THIS SHEET SUPPLEMENTS ORIGINAL SHT C6 AND SHALL BE USED FOR THE CONSTRUCTION OF THE CLOUDED INFORMATION ONLY. BINKLEY BARFIELD SHALL BE RESPONSIBLE FOR ALL OTHER DESIGN INFORMATION SHOWN.

**PARK PLACE WEST - PHASE III**  
**R. BALLARD SURVEY ABSTRACT NO. 29**  
**ROCKWALL, ROCKWALL COUNTY, TEXAS**  
**PAVING PLAN ALLEY A**

Sheet No:  
**C6.1**  
 OF 37

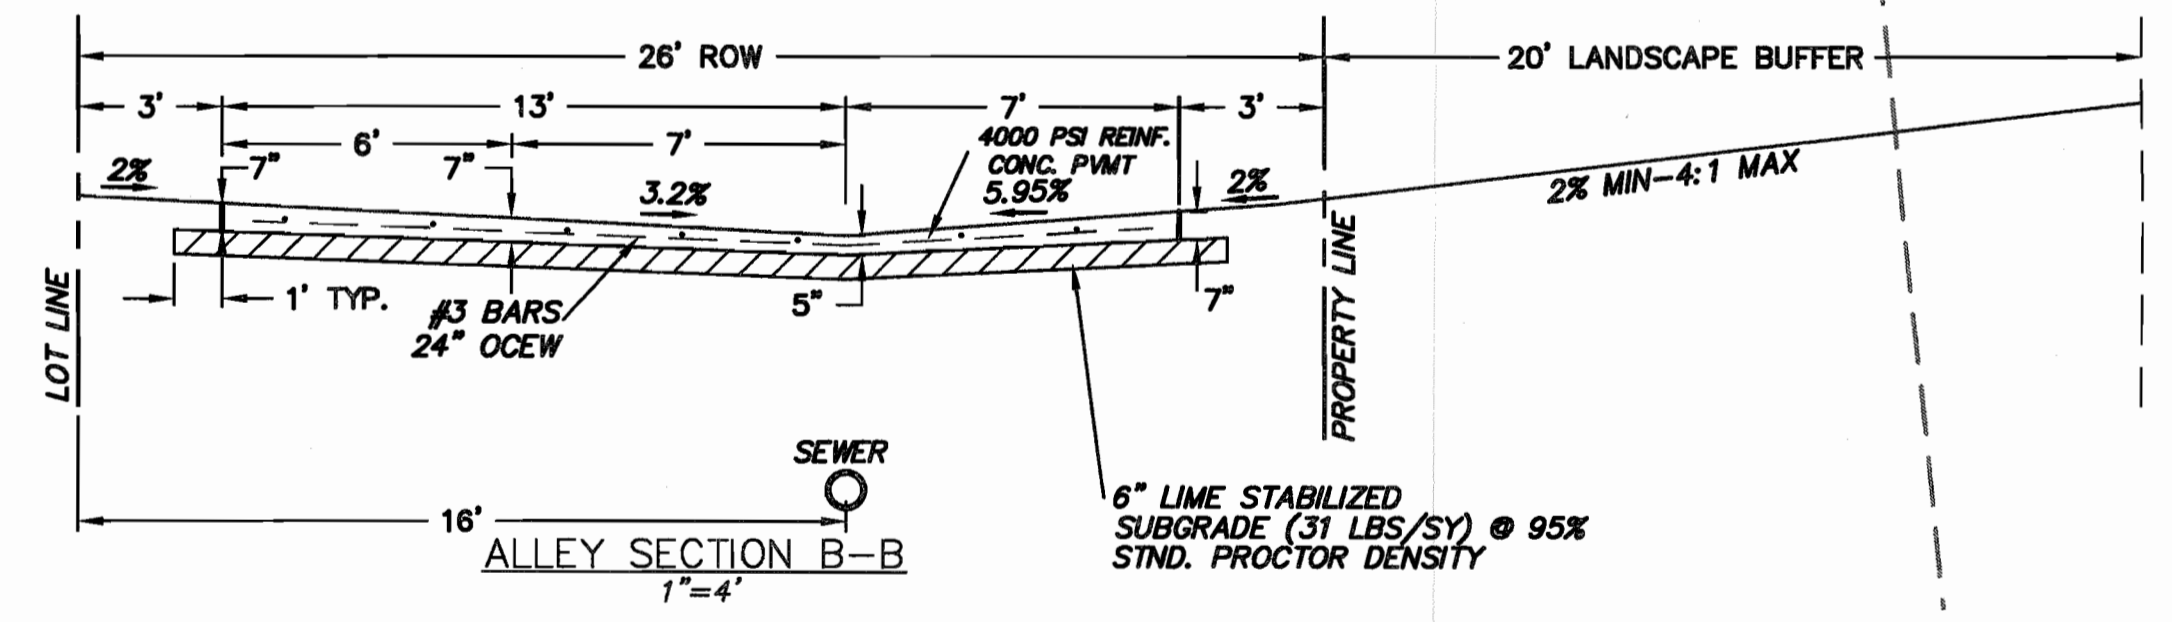
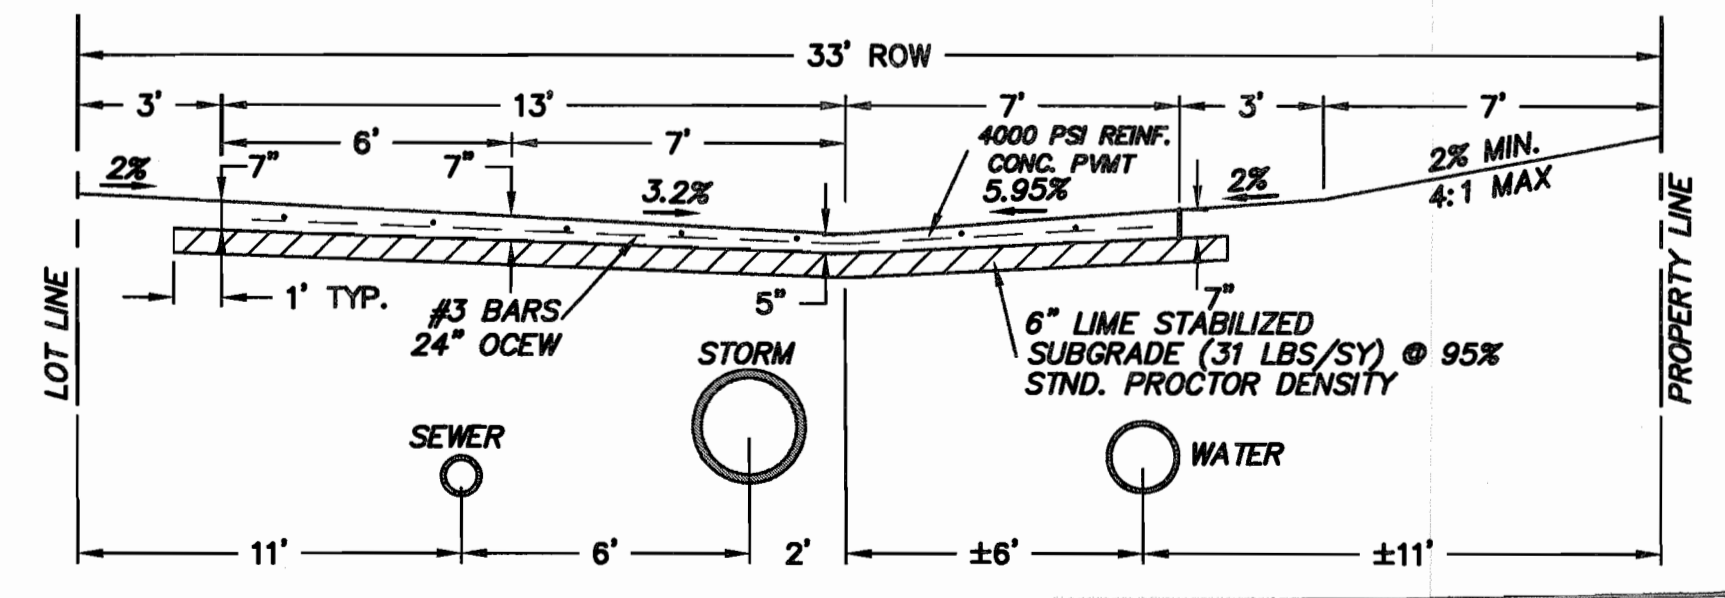
CITY MONUMENTS ADJUSTED SIDEWALK STORM INLET DELETED
